## Amendments of regulation No. 94 regarding electric safety (clean document)

The text reproduced below was prepared by the expert from France in order to extend the scope of the present Regulation to all kinds of power train systems above a certain working voltage level. The modifications to the existing text of the Regulation R 94 are based on informal document No. GRSP- 46-04, distributed during the forty sixth session of the Working Party on Passive Safety (GRSP) and discussions made at the 3<sup>rd</sup> EVPC adhoc group meeting held in Bonn, 11-12 march 2010, respectively. This informal document supersedes document ECE/TRANS/WP.29/GRSP/2010/20 distributed as an official document for the forty-seventh session of the Working Party on Passive Safety (GRSP). The modifications to the existing text of Regulation No. 94 are originally marked in bold or strikethrough characters and the modifications resulting from the EVPC meeting are highlighted in grey colour.

Additional amendments and corrections were introduced for clarification to take into account remarks received, in order to have one consolidated document. Modifications to the existing text GRSP 47-02/Rev.1 are deleted or m

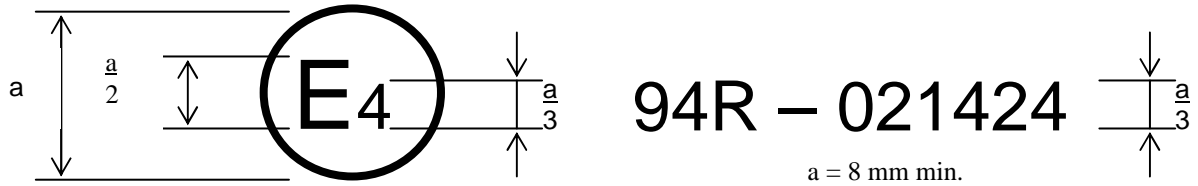
Annex 1, Communication, Insert a new paragraph 5.3., to read:

“5.3. Location of the electrical power source.....”

Model B

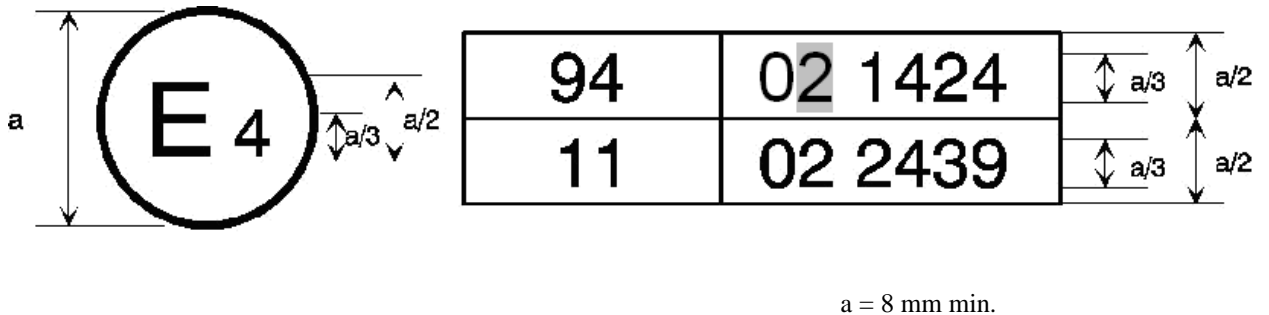
Annex 2, amend to read:

The above approval mark affixed to a vehicle shows that the vehicle type concerned has been approved in the Netherlands (E4) pursuant to Regulations Nos. 94 and 11. <sup>1/</sup> The first two digits of the approval numbers indicate that, at the dates when the respective approvals were granted, Regulation No. 94 incorporated the 02 series of amendments and Regulation No. 11 incorporated the 02 series of amendments.”
